Jones Gillam Renz Architects

The Residence at Green Meadow – JGR Proj 24-3395

ADDENDUM NO. 1

P1.4

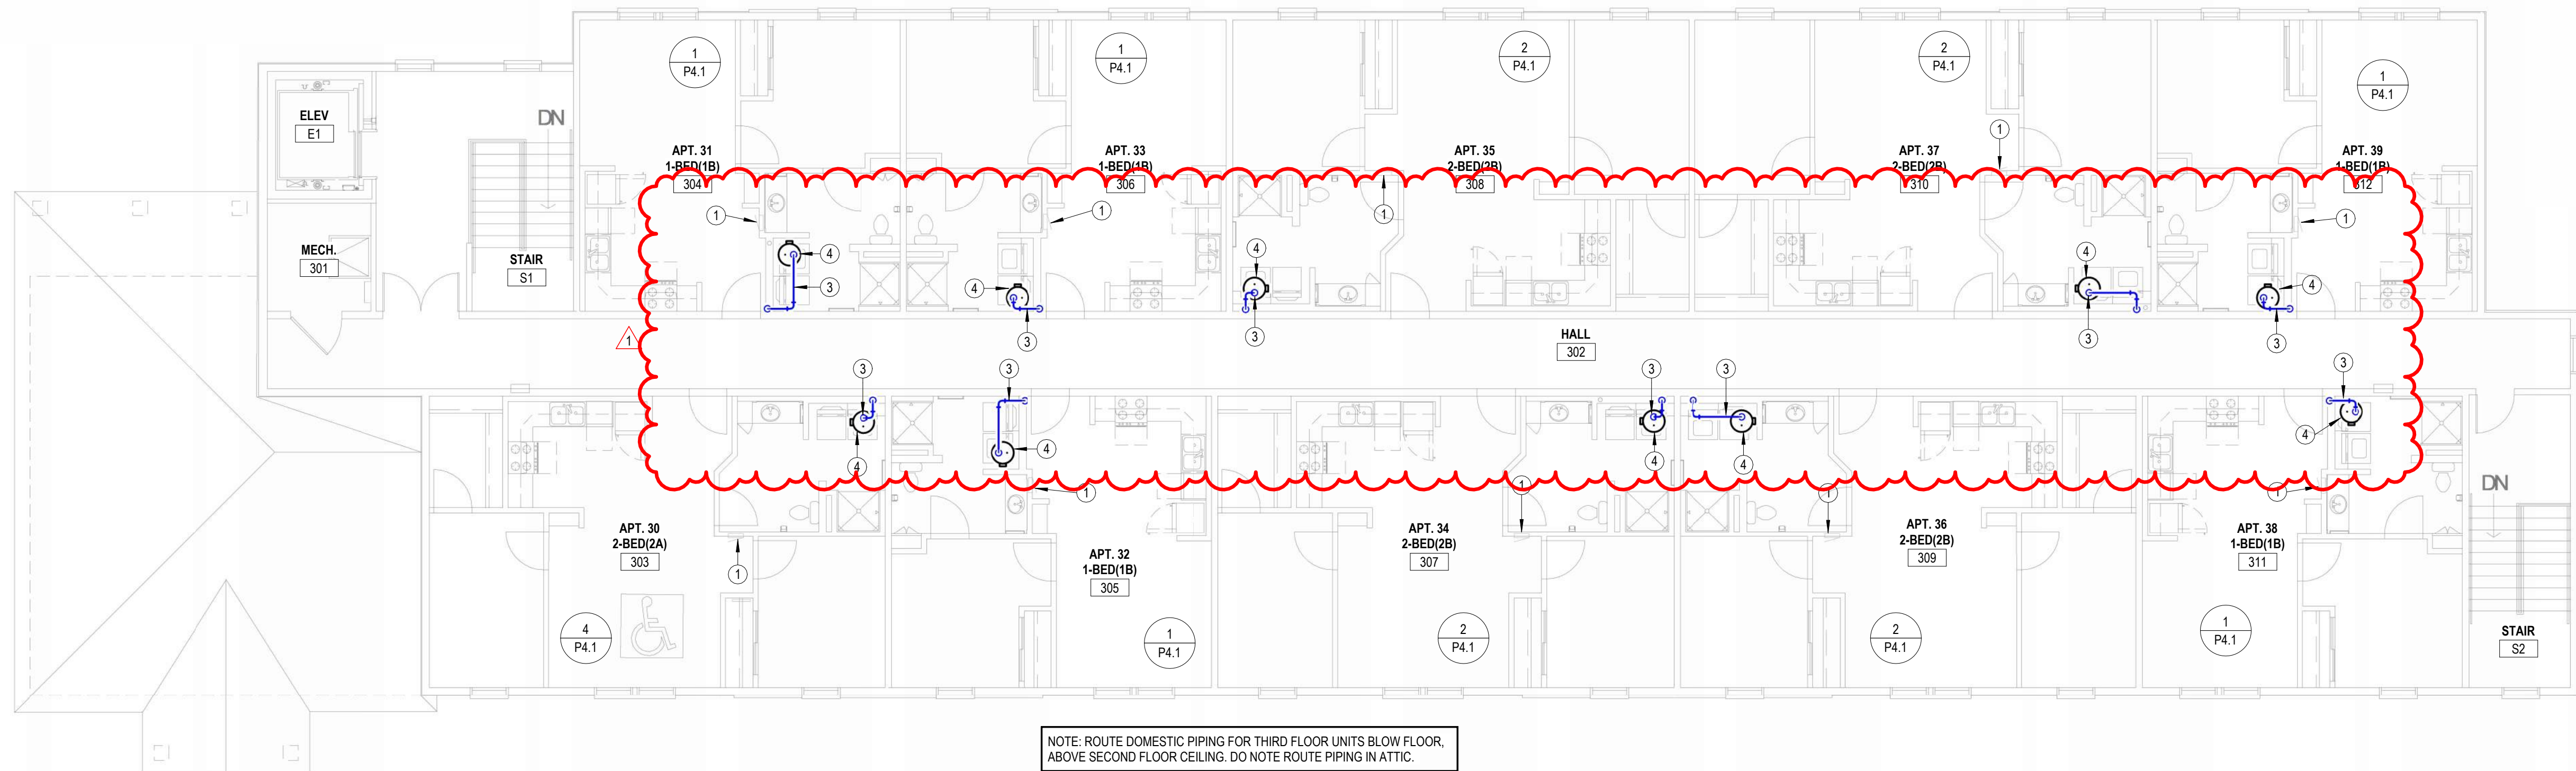
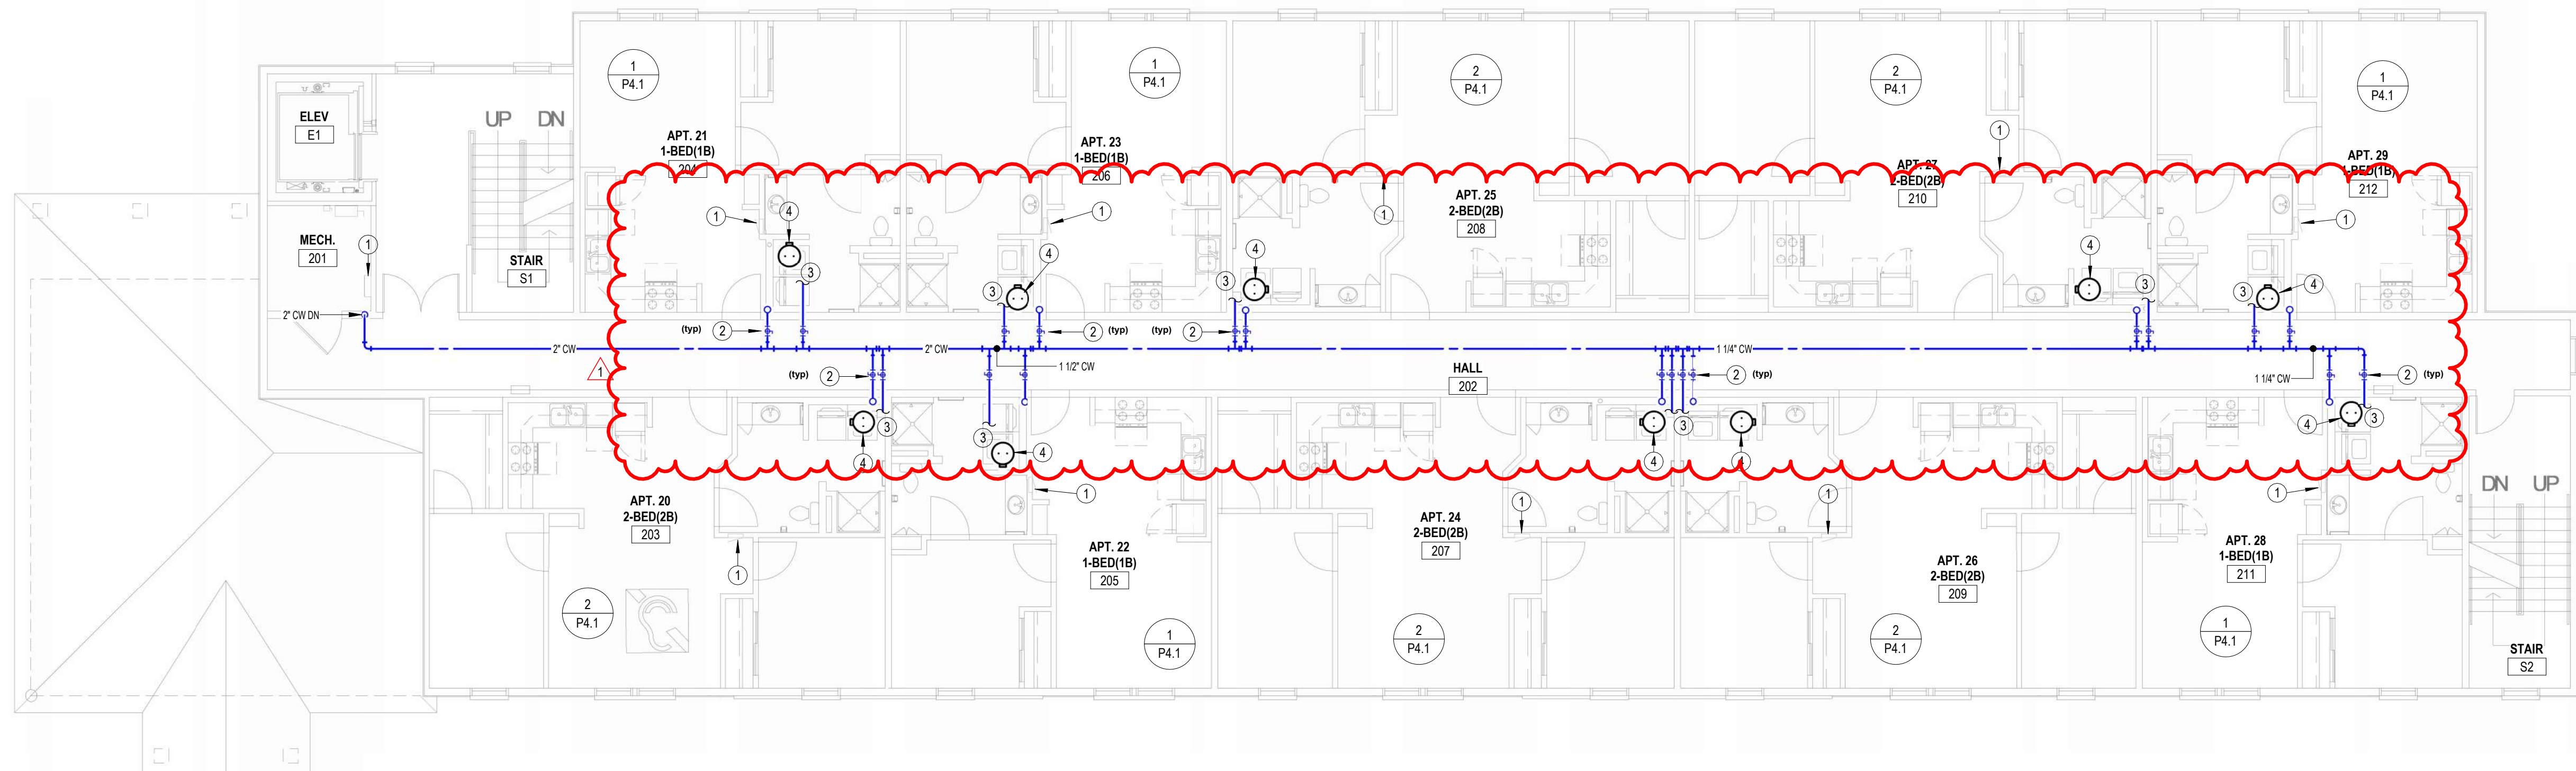
9. Sheet P1.3
 - a. Revised apartment domestic water piping for new HWH location
 - b. Added IECC compliance notes
10. Sheet P1.4
 - a. Revised apartment domestic water piping for new HWH location

- b. Added IECC compliance notes
11. Sheet P4.1
 - a. Revised apartment domestic water piping for new HWH location
 - b. Added IECC compliance notes
12. Sheet P6.1 – Revised descriptions of KS-A and KS-B

PROJECT SHALL COMPLY WITH ALL REQUIREMENTS OF 2021 IECC
NOTE: DOMESTIC HOT WATER PIPING INSULATION SHALL BE MINIMUM R-3.
